# Responses to CEC Data Requests Set Two (30-Day Extension)

Amended Application for Certification  
for  
**HYDROGEN ENERGY CALIFORNIA**  
(08-AFC-8A)  
Kern County, California

**RESPONSES TO DATA REQUESTS (30-Day Extension)  
FROM CALIFORNIA ENERGY COMMISSION (CEC)**

Revised Figure A149-1 Archaeological Survey Coverage

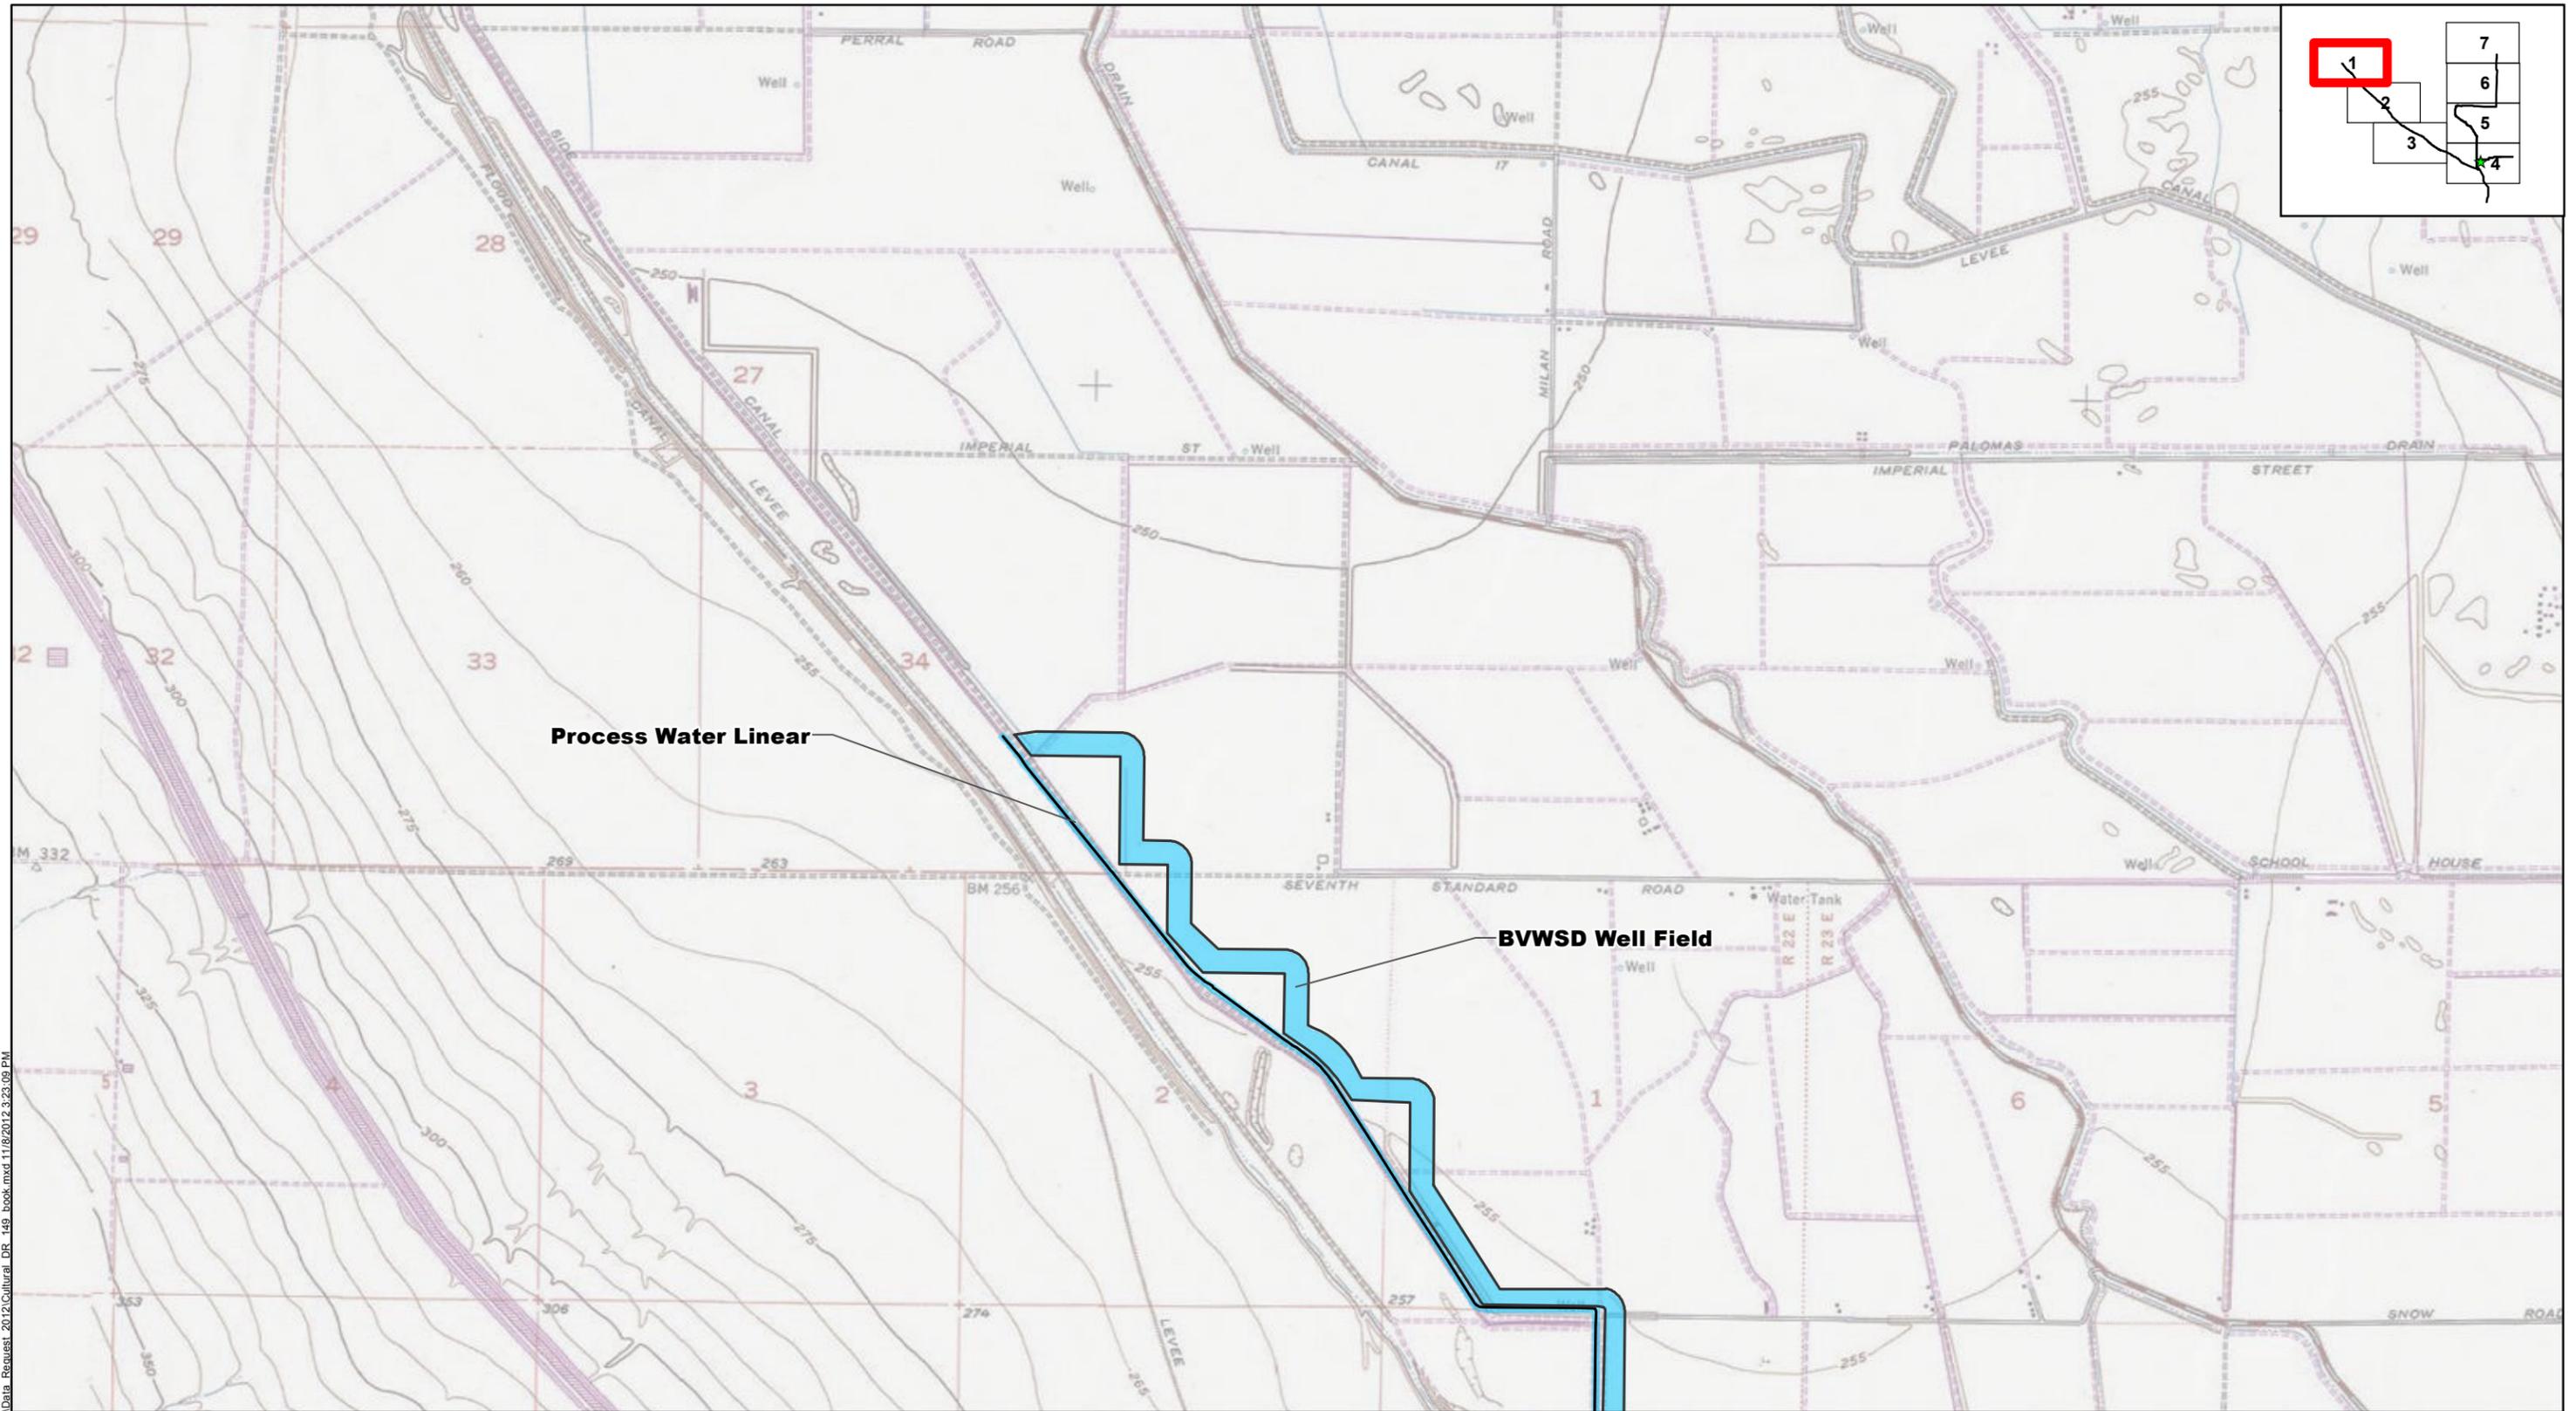
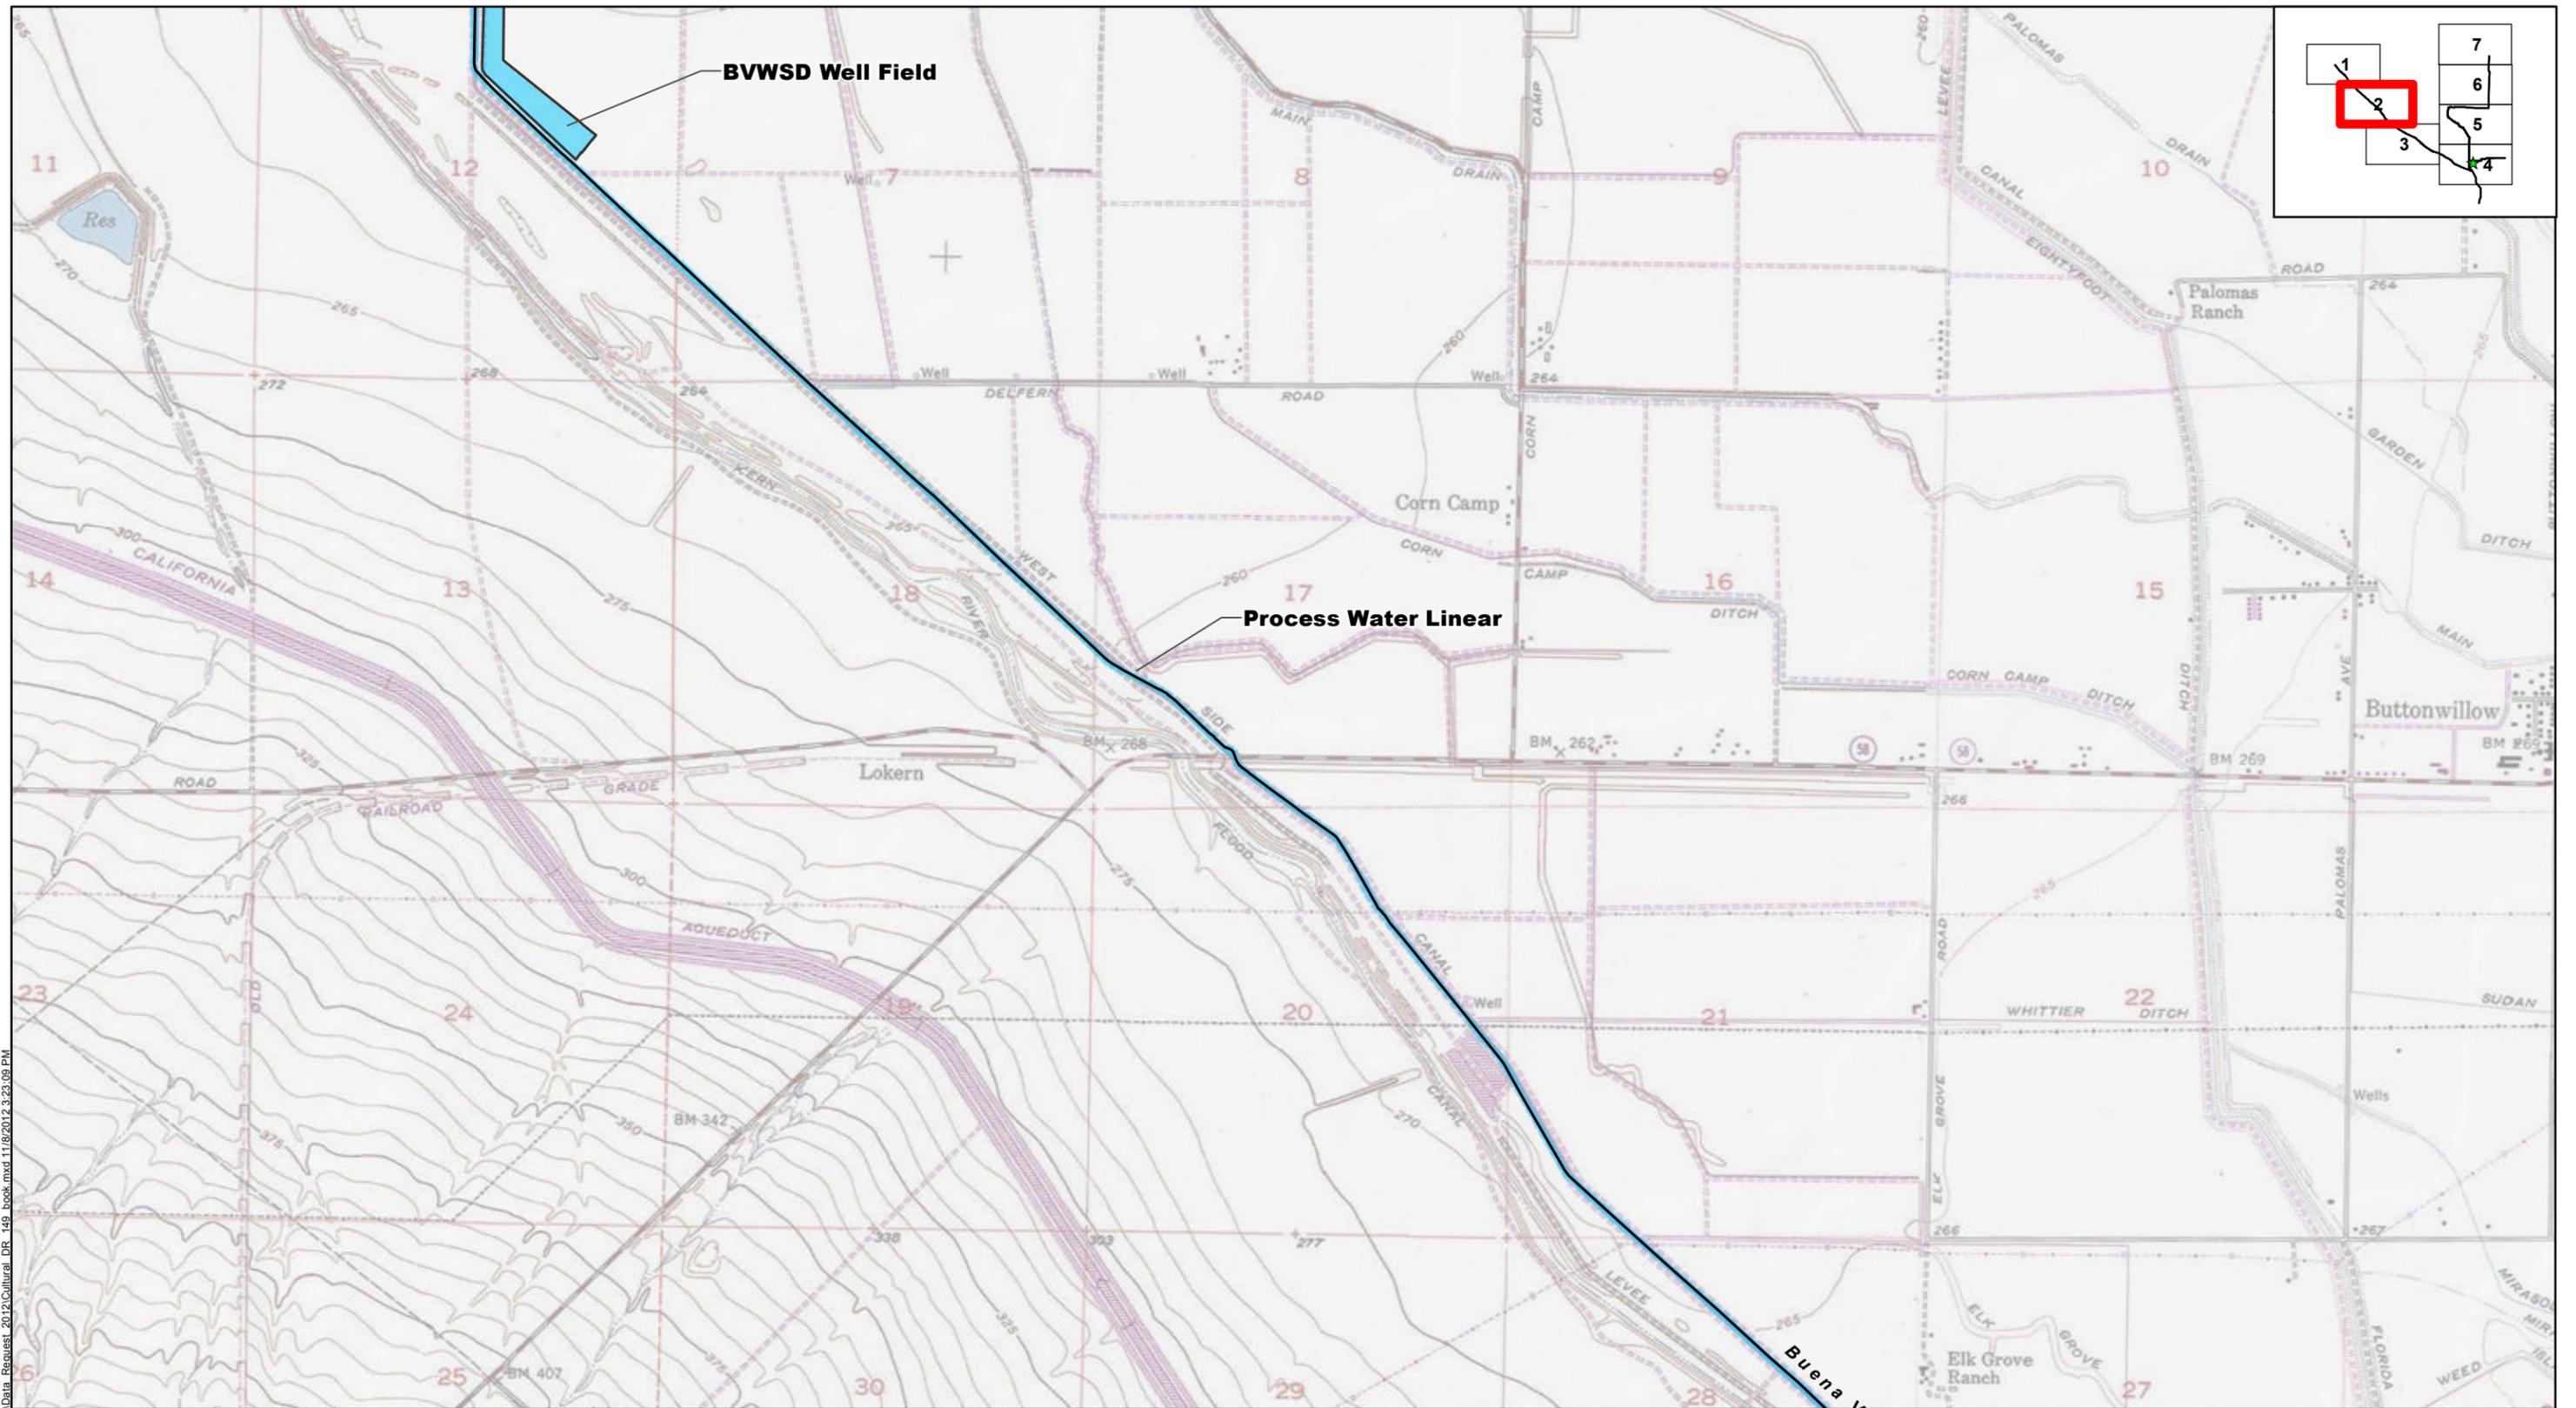
***A149. Please provide survey coverage figures on a 7.5-minute topographic quadrangle base (set at 7.5-minute scale). The figures must include all project elements and boundaries of the areas actually surveyed.***

Figure A149-1 has been updated to accurately reflect all unsurveyed areas to date; it replaces Figure A149-1 (Sheet 4), previously submitted with the responses to CEC Data Requests Set 2. The unsurveyed areas presented on Revised Figure A149-1 also update this element of the following figures previously submitted to the CEC:
